**Application by National Highways for  
an Order granting Development  
Consent for the Lower Thames  
Crossing (Ref. No. TR010032)**

**Submission for Examination Deadline 9  
– 15 December 2023**

**Emergency Services & Safety Partners  
Steering Group (ESSP SG)**

**Comments on Applicant's  
submissions at D8**

Drawing title **RVP north portal Option 2.2**

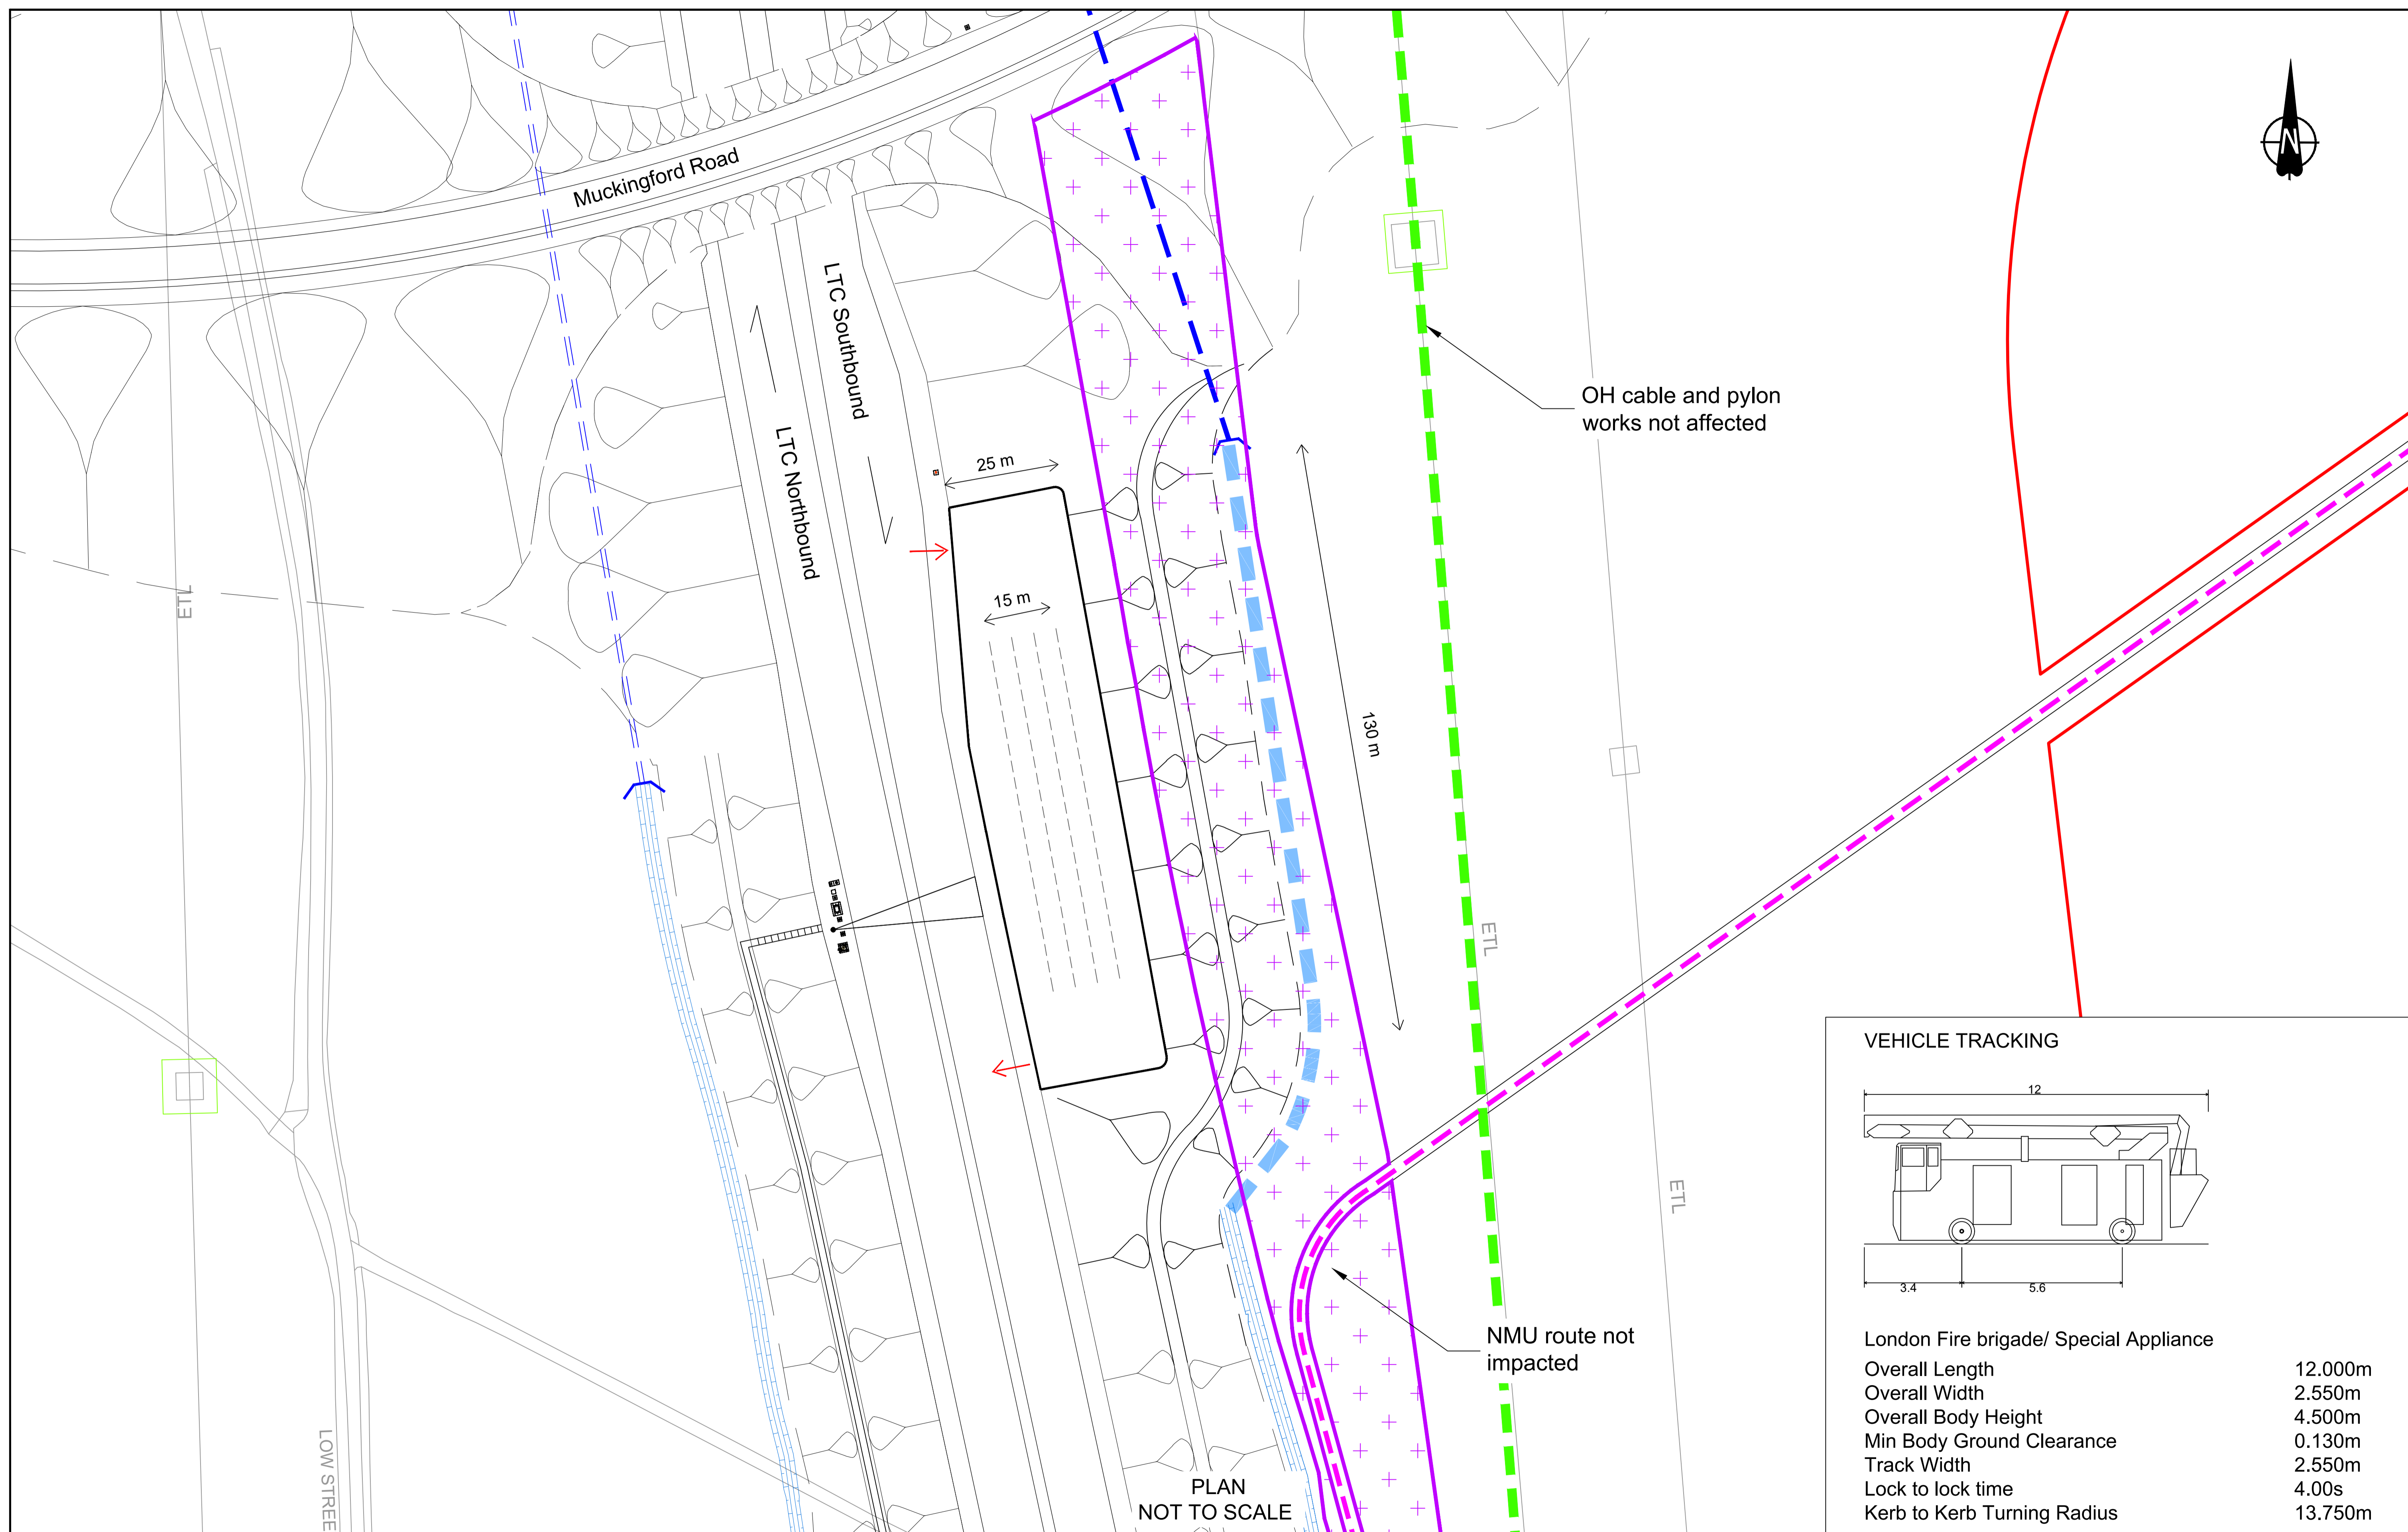
11. The ESSP SG position on the draft alternative RVP proposal contained in Appendix A to this submission is that it is, subject to further detailed design, acceptable in principle. This would be a drive on, drive off facility with five lanes to secure the muster of emergency services vehicles. The provision is 150m in length and 25m in width and is exactly what the ESSP SG have been requesting for a number of years.

17. The ESSP SG’s position is that ideally a suitable RVP for the project to the north of the River Thames should be secured by removing references to the current RVP and replacing it with the alternative proposal shown in Appendix A of this submission. This would involve changes to the following documents:

- c) amend Works Plans Volume C Composite (sheets 21 to 49) v6.0 ([REP7-041](#)) to show the alternative RVP on sheet 24
  - d) changing General Arrangement Plans Volume B (sheets 1 to 20) v4.0 Sheet 20 ([REP7-027](#)), to delete the current RVP at the north tunnel portal

- e) amend General Arrangement Plans Volume C (sheets 21 to 49) v5.0 ([REP7-029](#)) to show the alternative RVP on sheet 24.
  - f) amend the Design Principles v6.0 ([REP8-081](#)) as follows:
